**Application No.: 10/640,349**

**Docket No.: JCLA11051**

**In the Drawings:**

FIG. 1 (PRIOR ART)

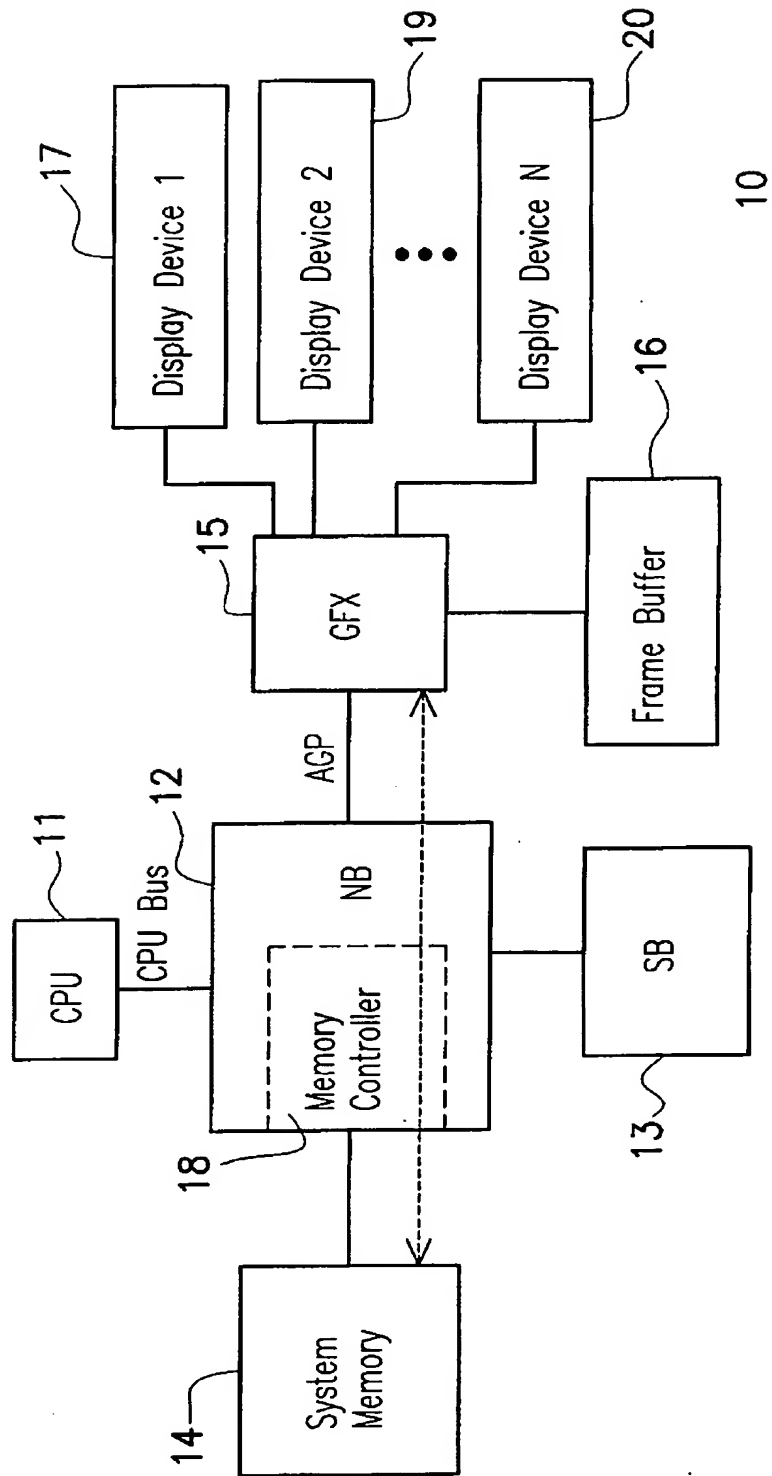
Please amend the drawings by replacing the original filed drawing sheets with the attached clear version of corrected drawing sheets, in which "prior art" marks are appropriately marked in FIGS. 1- 3, as they should be.

*Annotated Marked-up drawing*

FIG. 2 (PRIOR ART)

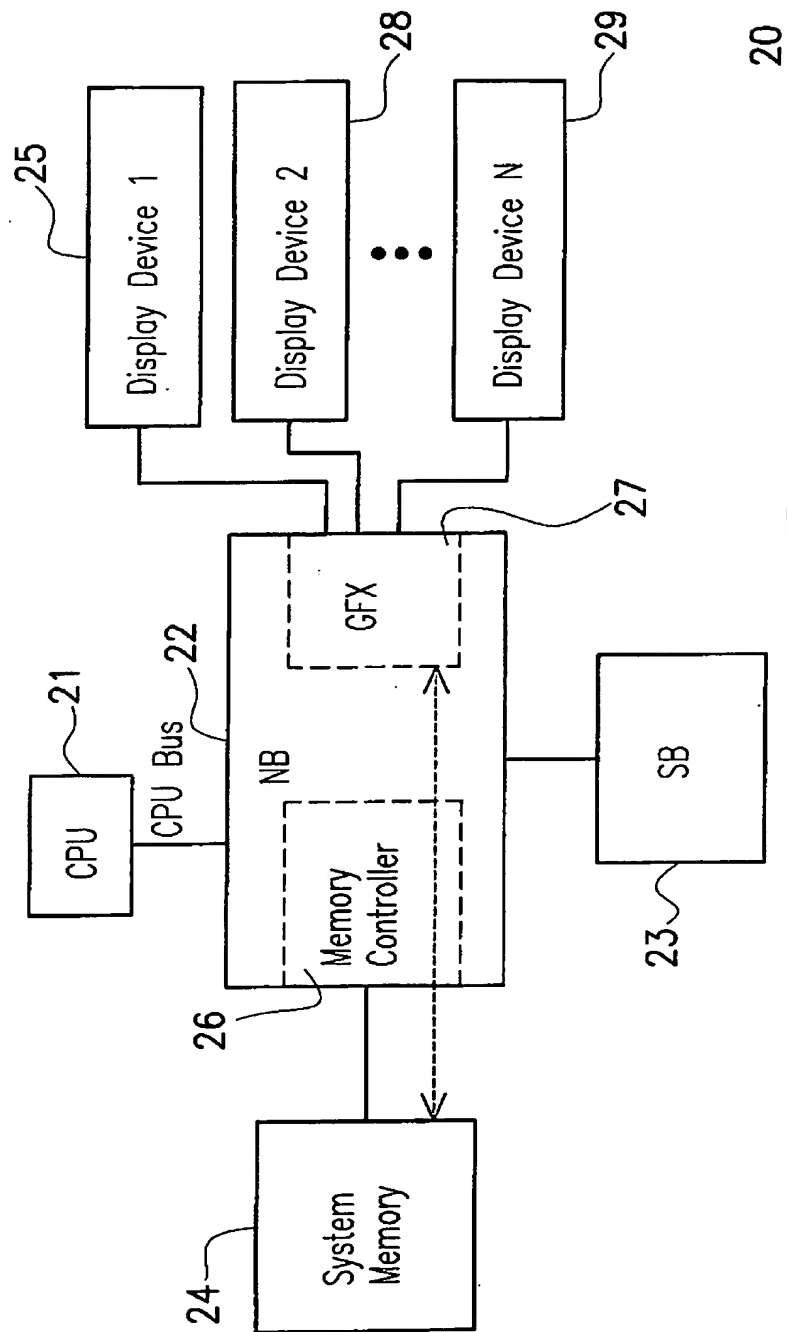
*Annotated Marked-up drawing*

FIG. 3 (PRIOR ART)

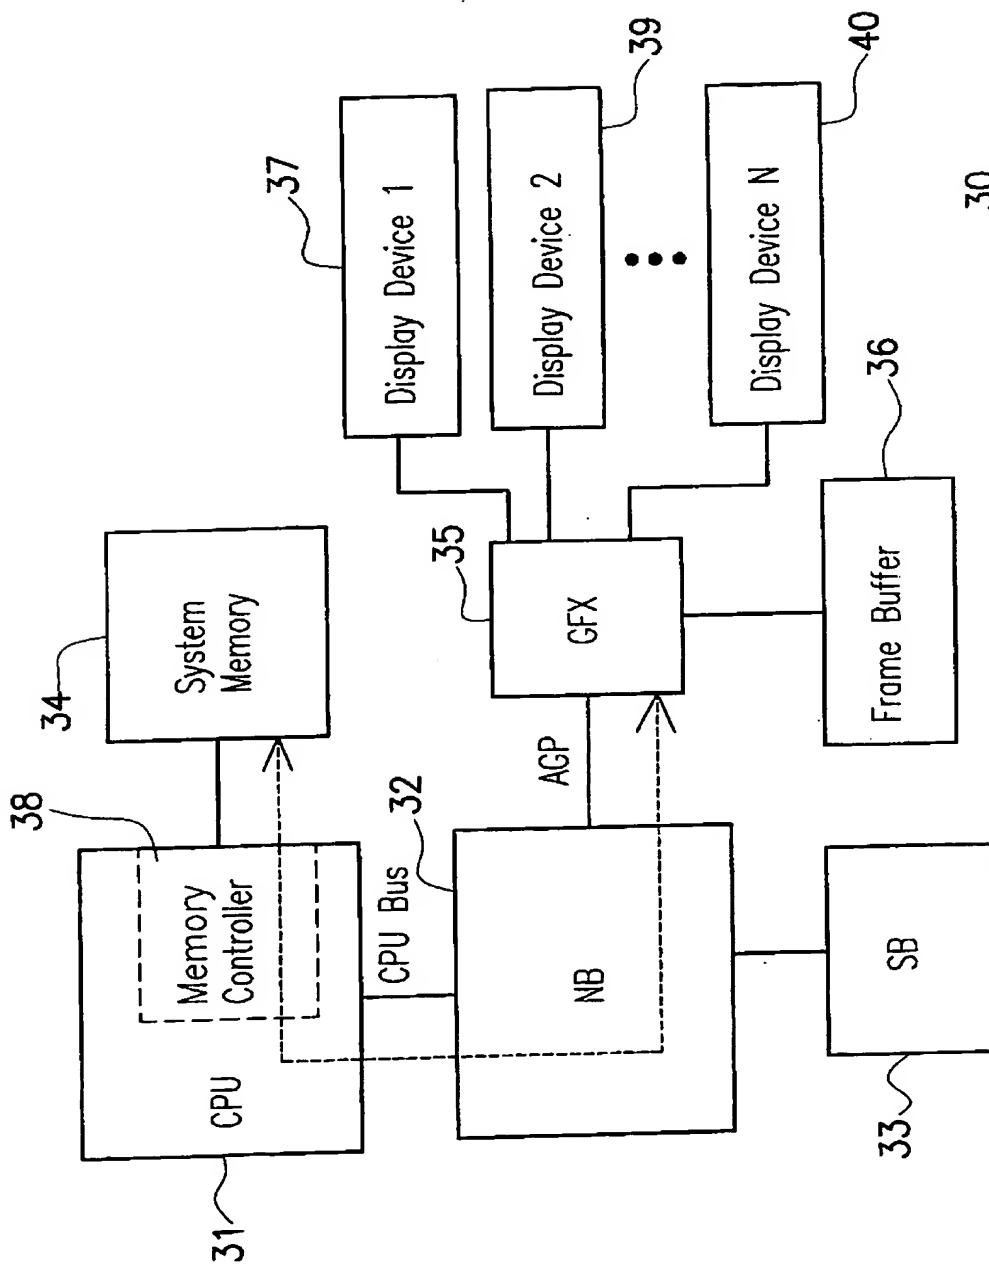
Annotated Marked-up drawing
